## PRODUCT / PROCESS CHANGE NOTIFICATION

1.1 Company	 STMicroelectronics International N.V
1.2 PCN No.	MICROCONTROLLERS/24/14844
1.3 Title of PCN	ST MUAR (Malaysia) additional source for STM32H74x/75x, STM32H72x/73x and STM32G47x/48x/G41x listed products in LQFP 14x14 100L package
1.4 Product Category	STM32H74x/75x STM32H72x/73x STM32G47x/48x/G41x
1.5 Issue date	2024-09-16

**ST MUAR (Malaysia) additional source for STM32H74x/75x,  
STM32H72x/73x and STM32G47x/48x/G41x listed products in  
LQFP 14x14 100L package**

Changes are described in table below:

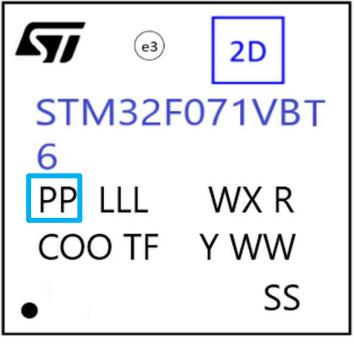
ST General Purpose Microcontrollers Division decided to qualify an additional back-end assembly site. The full process transfer to ST MUAR Assembly site is done maintaining state of the art service level to our customers thanks to extra capacity. This PCN is limited to STM32x listed products in LQFP 14x14 100L package.

Existing back-end lines					Added back-end line
Assembly site	ASE Kaohsiung (Taiwan)		AMKOR ATP (Philippine)			ST Muar (Malaysia)
STM32H74x/75x		X		X	X	X
STM32H72x/73x	X	X				X
STM32G47x/48x/G41x		X	X	X		X
LeadFrame	Copper, post-plated		Copper, pre-plated	Copper, post-plated		Copper, post-plated
Lead finishing <sup>(1)</sup>	Pure tin (e3)		NiPdAu (e4)	Pure tin (e3)		Pure tin (e3)
Molding Compound <sup>(2)</sup>	Sumitomo G631SH		Sumitomo G631HQ	Sumitomo G631SHQ		Sumitomo G700LS
Bonding Wire	Au 0.8MIL	CuPd 0.8MIL	Au 0.8MIL	CuPd 0.8MIL	Au 0.8MIL	Cu Alloy 0.8MIL
Die Attach Glue	SUMITOMO CRM 1076WA	HITACHI EN4900G	SUMITOMO CRM 1076YB	Ablestik 3230	Evertech AP4200	ABLESTIK ABP8302
Marking Composition	w/o 2D marking		w/o 2D marking	2D Marking		2D Marking
